# UNITED STATES PATENT AND TRADEMARK OFFICE

<b>Office Action Summary</b>	<b>Application No.</b> 29/788,007	<b>Applicant(s)</b> Boehm et al.	
	<b>Examiner</b> SHARON S OUM	<b>Art Unit</b> 2925	<b>AIA (FITF) Status</b> Yes

**OFFICE ACTION**

FIG. 2

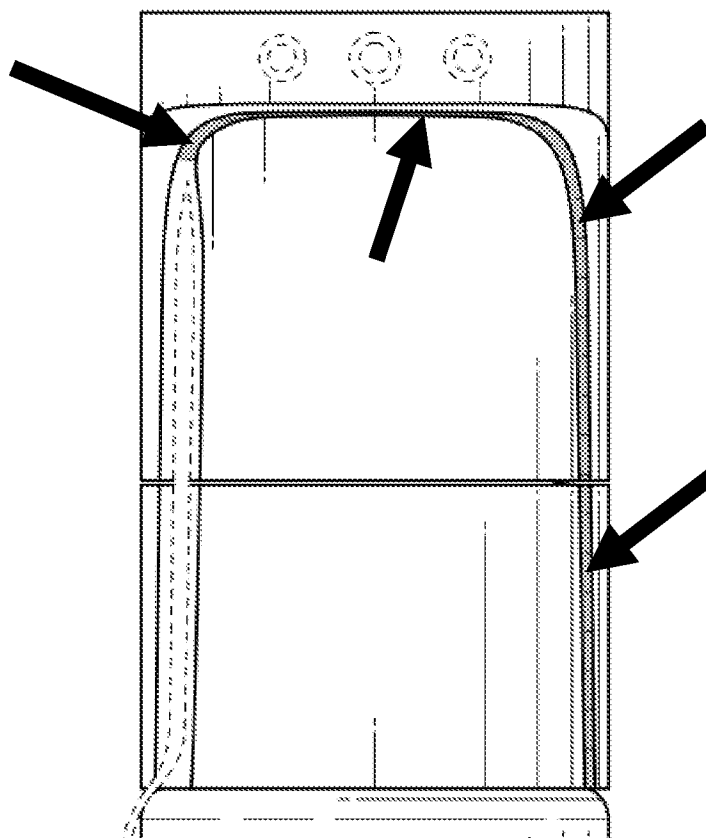
The claim is indefinite and nonenabling because of deficiencies in the figures that prevent a clear understanding of the appearance of the claimed design.

Specifically, FIG. 2 shows a long, narrow area (highlighted in gray and indicated with arrows in the image below) whose shape and form cannot be corroborated in the other views. The area is shaded such that contour is indicated, however, the exact three dimensional appearance cannot be understood from the views provided.

In order to overcome this rejection, it is suggested that the design be shown clearly and completely.
